NUCLEAR ENERGY INSTITUTE

# NEI 17-02

## Tornado Missile Risk Evaluator (TMRE) – Resolution of NRC Staff Comments

Figure 3-1. Plan View of Safety Related Structures

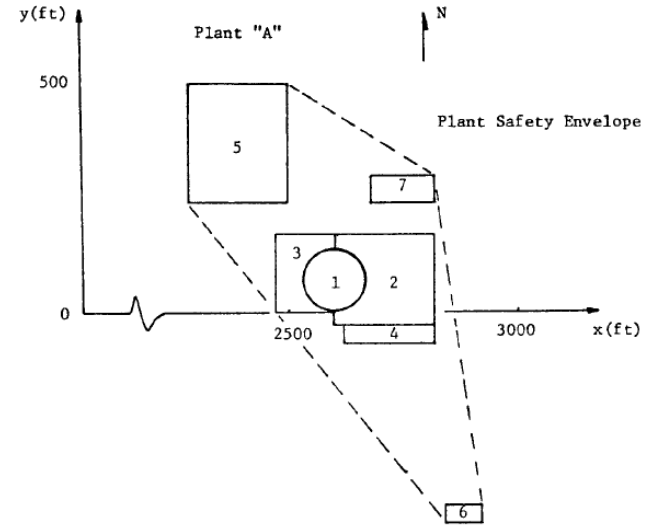
# #10.b - Response

- Building 1 (Containment) is 230 feet tall, but lower portion of building is completely shielded by Buildings 2 (Aux Bldg) and 3 (Fuel Handling Bldg)
  - Aux Bldg is 80 feet tall and Fuel Handling Bldg is 60 feet tall, so all exposed surfaces of Building 1 are >30' above grade
- EPRI NP-768 Plant A TORMIS simulations assume uniform distribution of initial missile elevations from 5' to 50' above grade, so some missiles are within 30' of exposed surface on west (FHB) side of Building 1

- Use of containment data in deriving <30' MIP leads to lower (less conservative) <30' MIPs
- >30' MIPs are derived in a conservative manner, since they include entire surface of all buildings, including surfaces less than 30' above grade
- TMRE methodology provides conservative tornado failure probabilities, when compared to TORMIS-based failure probabilities in RG 1.200 HW PRAs (Appendix A)
- Sensitivity case factors (2.5x and 2.75x) are significantly greater than increase in MIP, if it were derived without Building 1

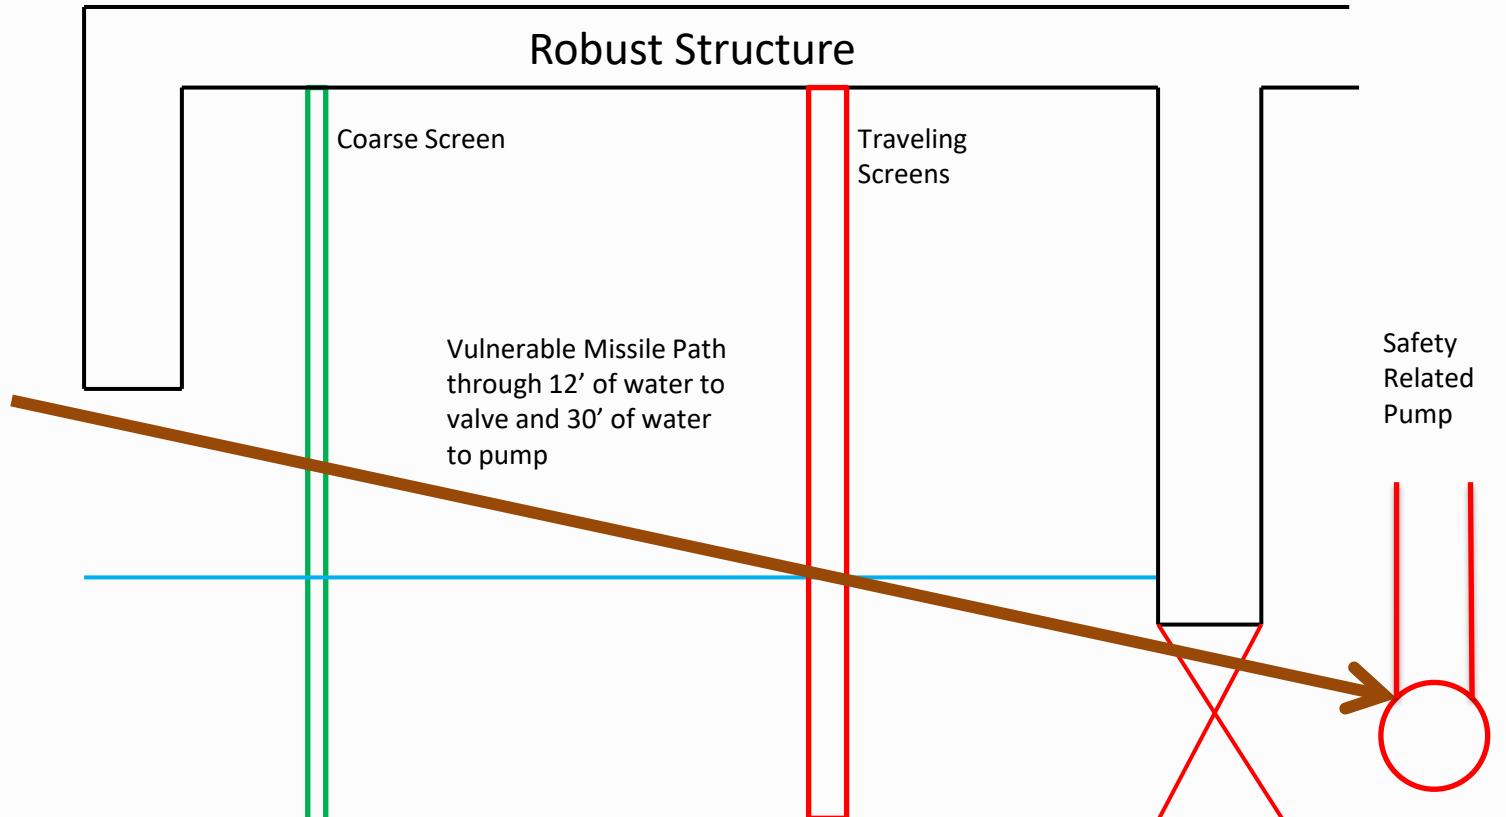
## #4.b - Response

- Vogtle and Grand Gulf pilot LARs for TMRE were also affected, as those requested approval of the methodology which could be applied in the future in the event of future discovery of additional non-conforming conditions.
- Vogtle and Grand Gulf are also withdrawing treatment of De Minimis penetrations, as described in NEI 17-02, Rev 1, from their LARs.
- NEI will revise NEI 17-02 to remove treatment of De Minimis penetrations so it will not be in the revision submitted to the staff for endorsement.
